LEVEL 5 CONDENSATE SENSOR MARKUP
AGC-8532-SK-LEVEL 5 CONDENSATE SENSOR
MARKUP-161101
Rev 3 - NM - 05/10/2016
Rev 4 - NM - 20/10/2016
Rev 5 - NM -27/10/2016
Rev 6 - NM

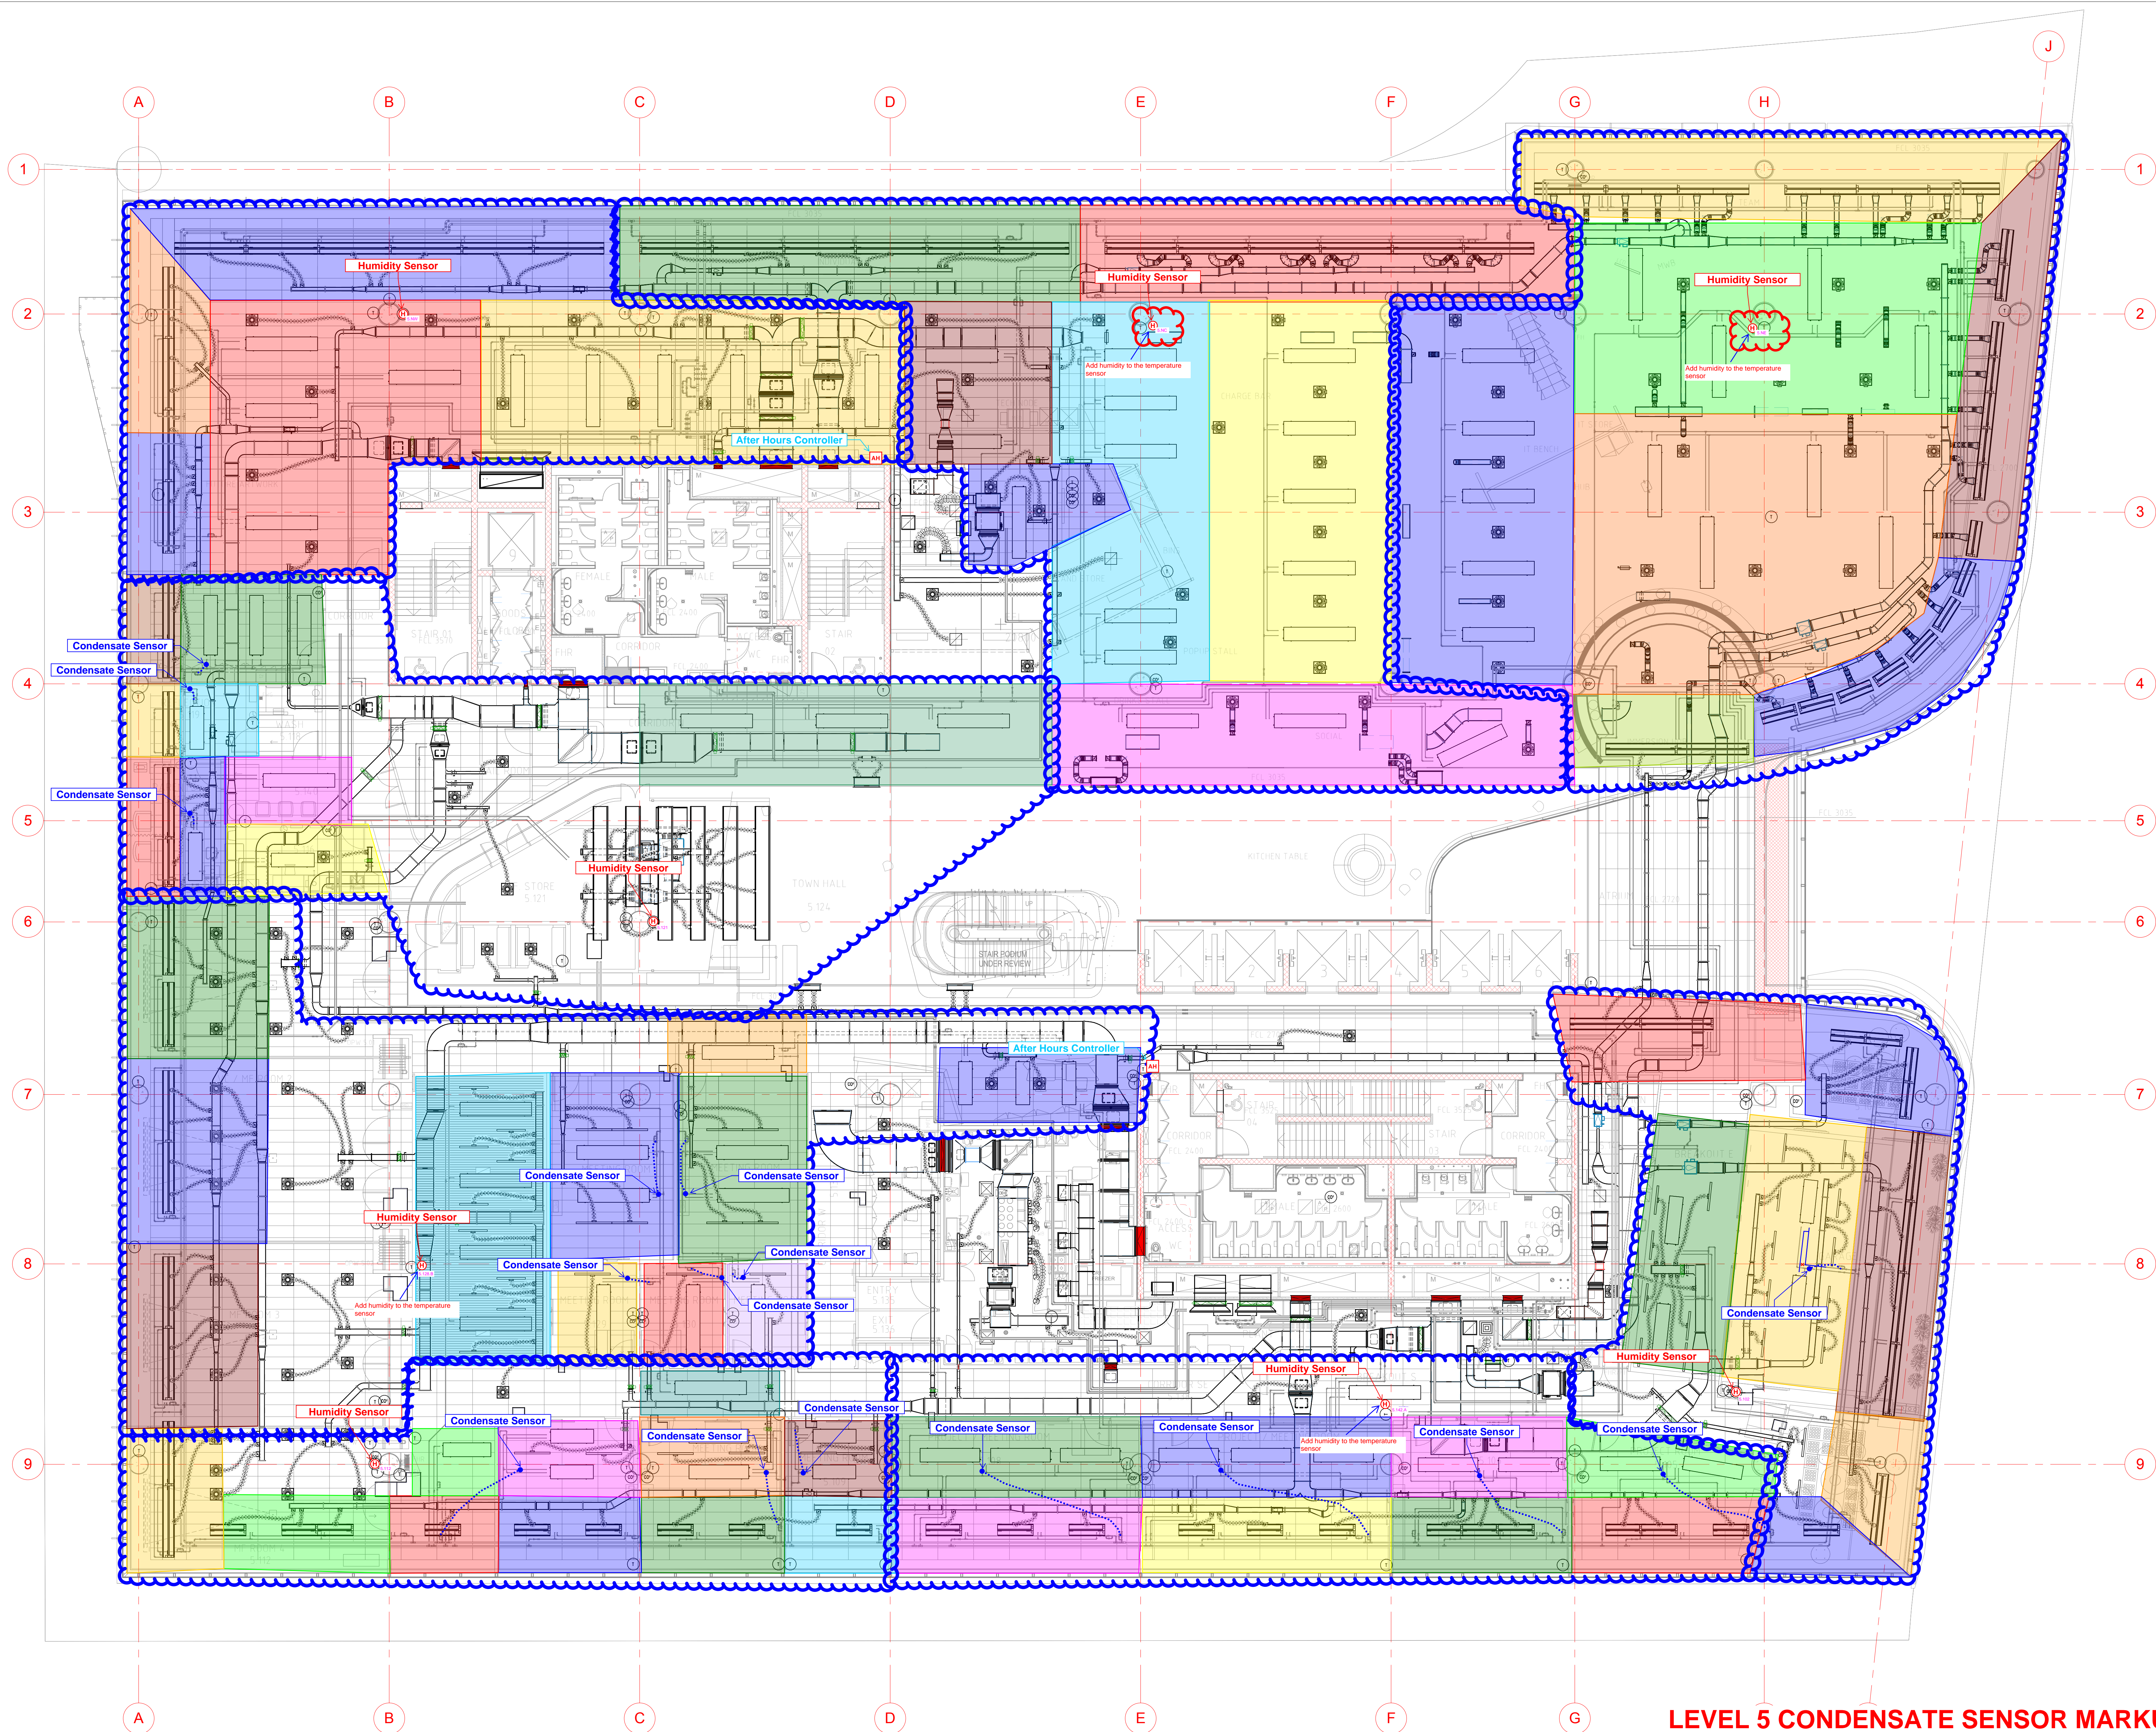
Typical
The condensate sensors at the take off for the first chilled beam served or adjacent to the take off if space is not permitted. Expose the CHW pipe insulation for 100mm and strap the sensor. To be installed as per the condensate sensor manufacturers specification.
